**PUBLIC HEARING MEMORANDUM**

SUBJECT: **Petition #88-19**, for SPECIAL PERMIT/SITE PLAN APPROVAL to allow a rear lot subdivision and to extend a nonconforming side setback at 41 Washington Street, Ward 1, Newton Corner, on land known as Section 71, Block 29, Lot 07, containing approximately 25,964 sq. ft. of land in a district zoned SINGLE RESIDENCE 3. Ref: §3.1.5, 3.1.10, §3.1.3, §7.3.3, §7.4, and §7.8.2.C.2 of Chapter 30 of the City of Newton Rev Zoning Ord, 2015.

## ZONING REVIEW MEMORANDUM

MEMORANDUM

### Proposed Site Plan

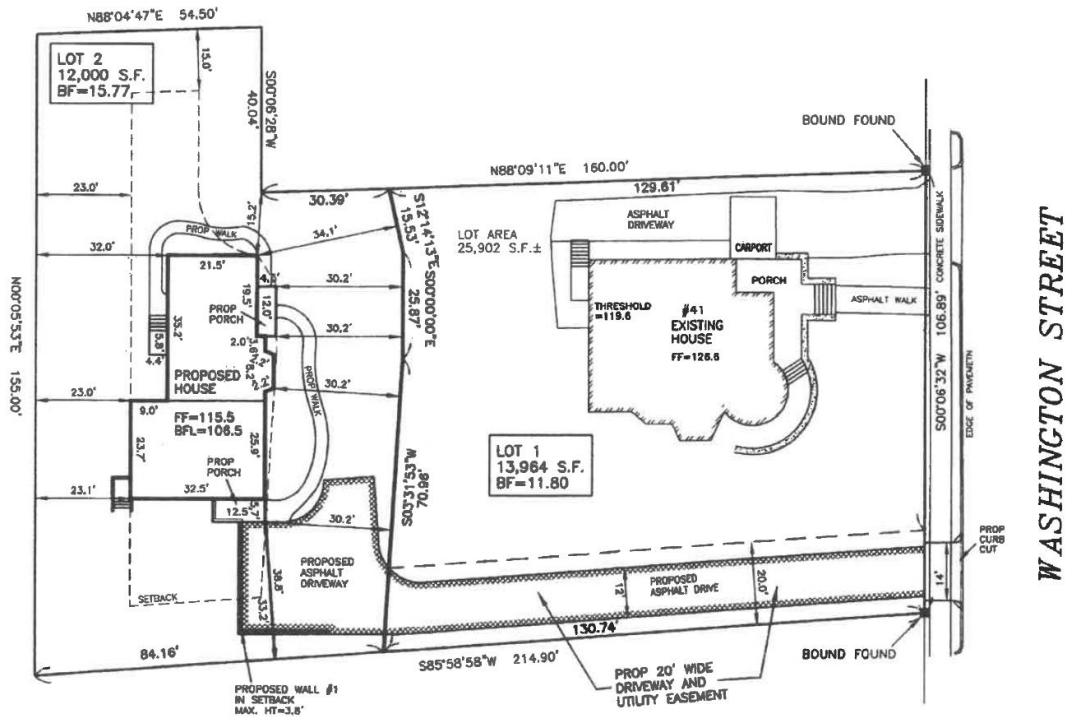
The petitioner is proposing to create a rear lot accessed via an easement over the existing front lot. This easement will be approximately 20-feet wide and 164 feet long, but only 12 feet of its width will be paved to allow for vehicular access; the remaining eight feet will be unimproved. This easement will be accessed from an approximately 14-foot wide curb cut from Washington Street at the southeastern portion of the front lot. The petitioner is not proposing any other changes to the front lot.

The proposed rear lot will be created approximately 45 feet from the rear of the existing dwelling. The rear lot will contain approximately 12,000 square feet and will be improved with a 1.5-story single-family dwelling. As stated above, the access will be in the form of an easement over the front lot, leading to a two-stall surface parking facility with a hammerhead for maneuvering. This parking facility will require the construction of a retaining wall, which is 3.8 feet at its tallest point within the setback. The petitioner is
